Access Compliance Report

Public Rights-of-Way

(Curb Ramps)

Intersection ID: 51443	Main Street: SHARON_RD	Cross Street: ASHLEY_PARK_LN	Location: SW
ADA ID: CBA55325D89B	Ramp Type: Perp	Initial Pass/Fail: Fail	Overall Compliance: No
		Severity Score: 12.5	
Codes/Mitigation Info/Possible Solution		Field Measurements/Component Compliance

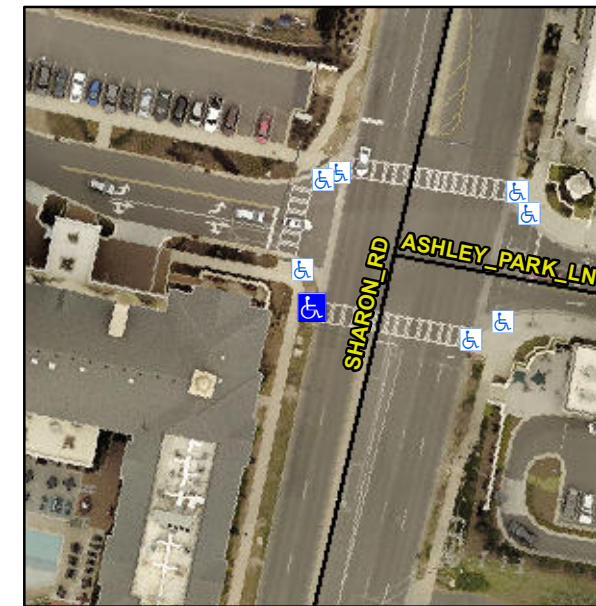
Not Found, R304.2.2

Compliance	Description	Data	Compliance	Description	Data
N/A	Ramp Length (in)	95.0	No	Ramp Slope (%)	9.6
Yes	Ramp Width (in)	83.0	Yes	Ramp XSlope (%)	1.0
N/A	Flare Type LT	N/A	N/A	Flare Type RT	N/A
N/A	Flare Slope LT (%)	N/A	N/A	Flare Slope RT (%)	N/A
N/A	Flare Traversable LT?	N/A	N/A	Flare Traversable RT?	N/A
N/A	Landing Length (in)	N/A	N/A	DWS Provided?	N/A
N/A	Landing Width (in)	N/A	N/A	DWS Contrast?	N/A
N/A	Landing Slope (%)	N/A	N/A	DWS Length (in)	N/A
N/A	Landing X Slope (%)	N/A	N/A	DWS Full Width?	N/A
N/A	Landing Curb? (Y/N)	N/A	N/A	DWS Offset (in)	N/A
N/A	Shared Landing?	N/A			
N/A	Gutter Ponding?	N/A	N/A	Gutter Slope (%)	N/A
N/A	Gutter Lip Ht (in)	N/A	N/A	Gutter X Slope (%)	N/A
N/A	Painted X Walk1?	Yes	N/A	Painted X Walk2?	N/A
	X Walk 1 Direction	To SE		X Walk 2 Direction	N/A
N/A	X Walk 1 Width (in)	112.0	N/A	X Walk 2 Width (in)	N/A
	X Walk 1 Slope (%)	6.0		X Walk 2 Slope (%)	N/A
	X Walk 1 X Slope (%)	1.3		X Walk 2 X Slope (%)	N/A

Remove & Replace Entire Ramp.
